Access Compliance Report

Public Rights-of-Way

(Curb Ramps)

Intersection ID: 22044	Main Street: HAVERSTICK_PL	Cross Street: MILL_POND_RD	Location: S
ADA ID: BF6BE2DE9A28	Ramp Type: PerpDiag	Initial Pass/Fail: Fail	Overall Compliance: No
		Severity Score: 22.5

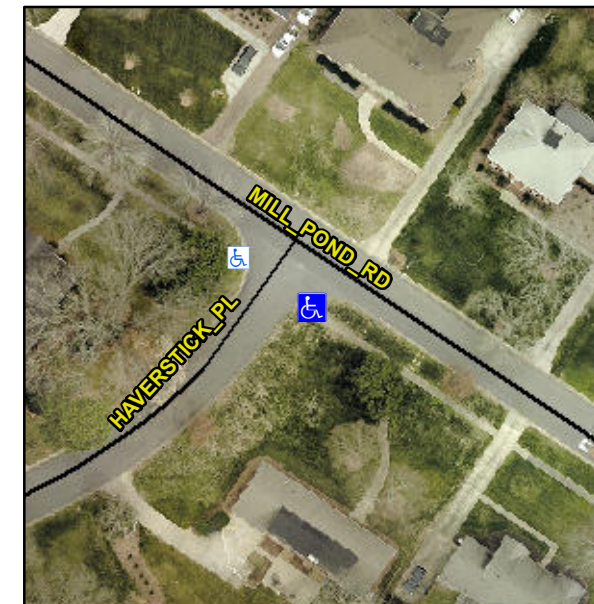
Not Found, R304.5.1, R304.2.2, R304.5.3

Compliance	Description	Data	Compliance	Description	Data
N/A	Ramp Length (in)	114.0	No	Ramp Slope (%)	8.5
No	Ramp Width (in)	45.0	No	Ramp XSlope (%)	2.1
N/A	Flare Type LT	N/A	N/A	Flare Type RT	N/A
N/A	Flare Slope LT (%)	N/A	N/A	Flare Slope RT (%)	N/A
N/A	Flare Traversable LT?	N/A	N/A	Flare Traversable RT?	N/A
N/A	Landing Length (in)	N/A	N/A	DWS Provided?	N/A
N/A	Landing Width (in)	N/A	N/A	DWS Contrast?	N/A
N/A	Landing Slope (%)	N/A	N/A	DWS Length (in)	N/A
N/A	Landing X Slope (%)	N/A	N/A	DWS Full Width?	N/A
N/A	Landing Curb? (Y/N)	N/A	N/A	DWS Offset (in)	N/A
N/A	Shared Landing?	N/A			
N/A	Gutter Ponding?	N/A	N/A	Gutter Slope (%)	N/A
N/A	Gutter Lip Ht (in)	N/A	N/A	Gutter X Slope (%)	N/A
N/A	Painted X Walk1?	No	N/A	Painted X Walk2?	No
	X Walk 1 Direction	To NE		X Walk 2 Direction	To NW
N/A	X Walk 1 Width (in)	N/A	N/A	X Walk 2 Width (in)	N/A
	X Walk 1 Slope (%)	5.8		X Walk 2 Slope (%)	2.1
	X Walk 1 X Slope (%)	2.0		X Walk 2 X Slope (%)	4.7

Remove & Replace Curb Ramp With Two New Directional Ramps or Equivalent.
